# Riverfront Park

FINAL  
ENVIRONMENTAL IMPACT REPORT  
STATE CLEARINGHOUSE NUMBER 2002051146  
NOVEMBER 2002

**SUBJECT:** Maywood Riverfront Park Project

## **Final Environmental Impact Report**

**Figure 2.0.10  
Proposed Project Site Plan**

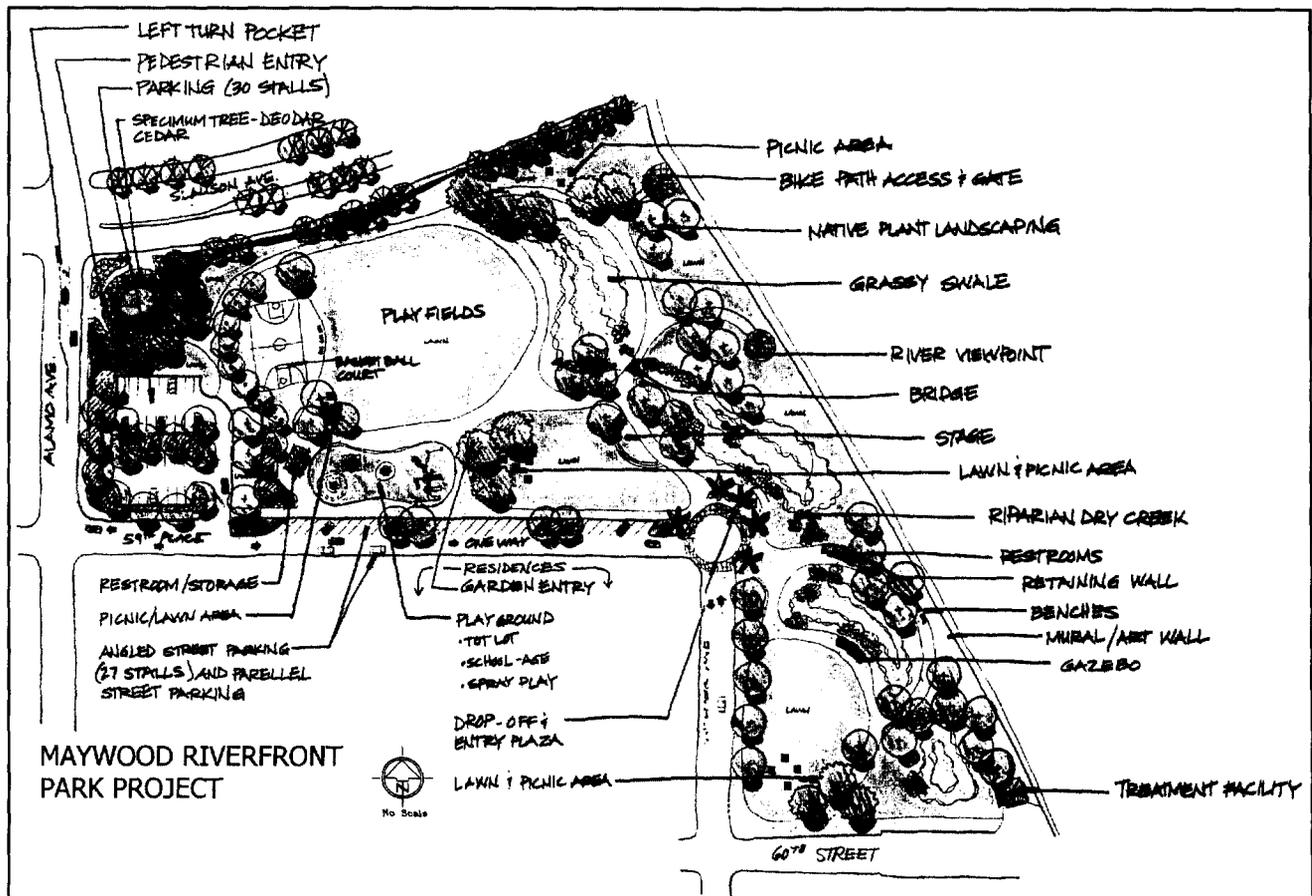
6. The proposed Project site plan (Figure 2.0.10) should include future drainage information. Drainage to the Los Angeles River or to other storm drains in the area shall be discussed more explicitly in the EIR.

The park has been designed to maximize watershed management opportunities to capture local rainfall on the project site. Additionally, design of the park incorporates elimination of the incremental increase in the flows to the storm drain system and provides filtering of flows to capture containment originating from the project site. This is evident in the site grading and drainage plans (Figure 3.4.1 and Figure 3.4.2) included in the EIR.
